METROPOLITAN GOVERNMENT OF NASHVILLE AND DAVIDSON COUNTY

STAFF RECOMMENDATION 1103 McKennie Avenue May 17, 2017

Application: New construction—addition and DADU; Setback determination

Description of Project: Application is to construct a rear addition and a detached accessory dwelling unit (DADU). The addition requires a side setback determination. Base zoning requires a five foot (5') side setback, and the applicant is proposing an addition that is approximately three feet, six inches (3'6") from the side property line. The addition also involved enclosing a side porch and enlarging a door opening.

DADU ELEVATIONS

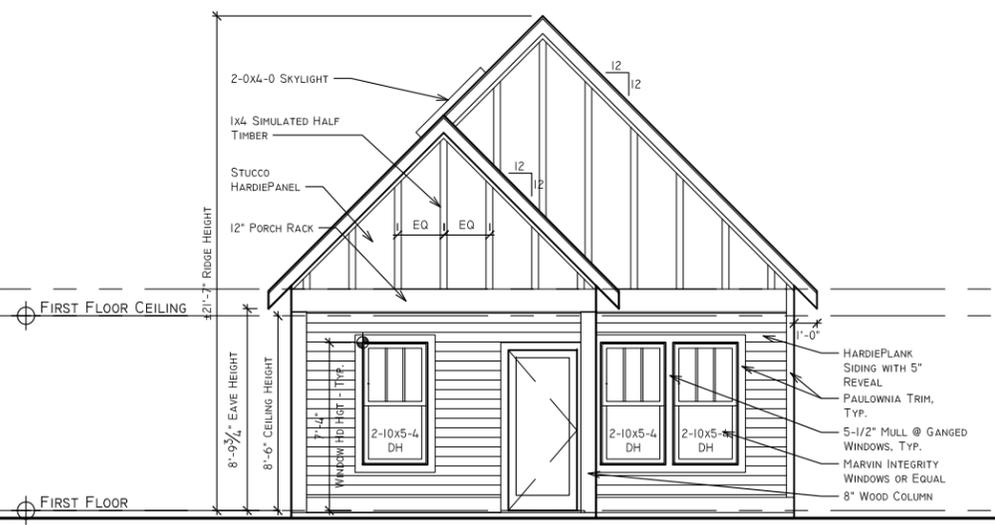
Proposed Element	Proposed Form	Typical of district?
Primary form	Gable	Yes
Primary roof slope	12/12	Yes
Porch form	Gable	Yes
Porch slope	12/12	Yes

Design Standards: The accessory structure has a simple, utilitarian design that is appropriate for outbuildings. Its roof form, detailing, and form do not contrast greatly with the primary structure. It is in a minimally-visible location at rear of the site. Staff finds that the DADU’s design meets section II.B.h.1 of the design guidelines and Section 17.16.030.G.8 of the ordinance.

Proposed	Color/Texture	Approved Previously or Typical of Neighborhood
Foundation	Concrete slab	Typical	Yes
Cladding	Cement-fiber	Smooth with 5” reveal	Yes
Secondary	Board and	Smooth	Yes

Cladding	Batten		
Roofing	Asphalt shingle	Match existing house	Yes
Trim	Cement fiber	Smooth	Yes
Porch floor	Concrete slab	Typical	Yes
Porch Posts	Wood	Typical	Yes
Windows	Fiberglass Clad	Marvin Integrity	Yes
Pedestrian Door	Unknown	Needs final approval	Unknown
Vehicular Door	Unknown	Needs final approval	Unknown

With the staff's final approval of the doors and material information that has not yet been provided, staff finds that the known materials meet Section II.B.h.1. of the design guidelines.
